TECHNICAL SERVICE BULLETIN

SUBJECT: TRANSMISSION LINKAGE DEFLECTION AND
EXCESSIVE REVERSE ENGAGEMENT EFFORT
CORVAIR "95" MODELS WITH 4-SPEED
TRANSMISSION

BULLETIN NO. DR # 460

DATE December 16, 1960

COUPLING REWORKED BY WELDING

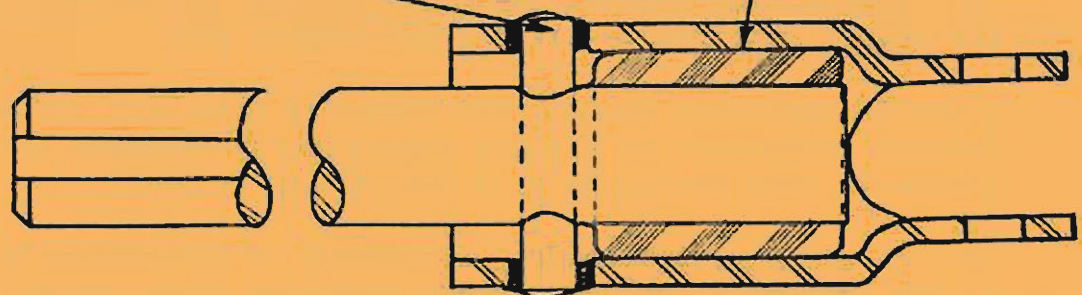
A new Transmission Control Rod Coupling with less deflection entered Production on 4-speed transmission equipped units effective with Serial No's. F-101736 and S-104752.

Should excessive deflection, resulting in indefinite or poor detent feel exist on early units with the first design coupling, the coupling pin should be arc welded to the coupling bell as shown on Page 2.

NOTE: It is important that the part be quenched in water immediately after arc welding to prevent deterioration of the rubber bushing.

ARC WELD ALL AROUND
BOTH SIDES AS SHOWN

IMPORTANT: WATER QUENCH IMMEDIATELY AFTER
WELDING TO PREVENT DETERIORATION
OF RUBBER

REVERSE GEAR INHIBITOR

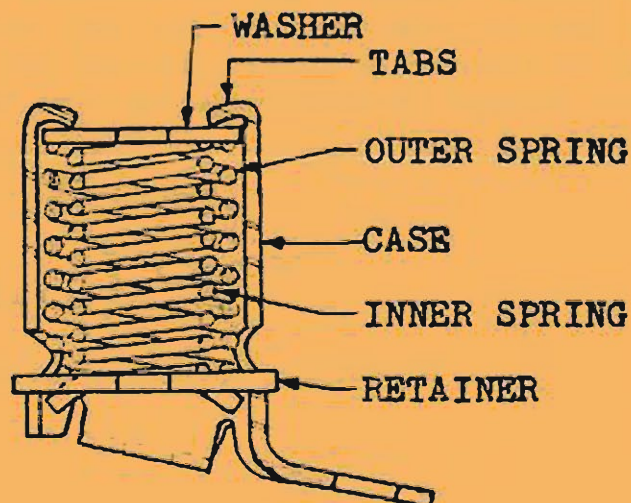
Corvair "95" 4-speed transmissions built after 11/8/60 (Trans. #1108) incorporate a new single spring type reverse inhibitor. The early design inhibitor may be reworked to reduce shifting effort by removing the inner of the dual springs. The inner spring may be removed by first removing the retainer (See Page 2). Do not attempt to remove spring from the top side by prying up tabs.
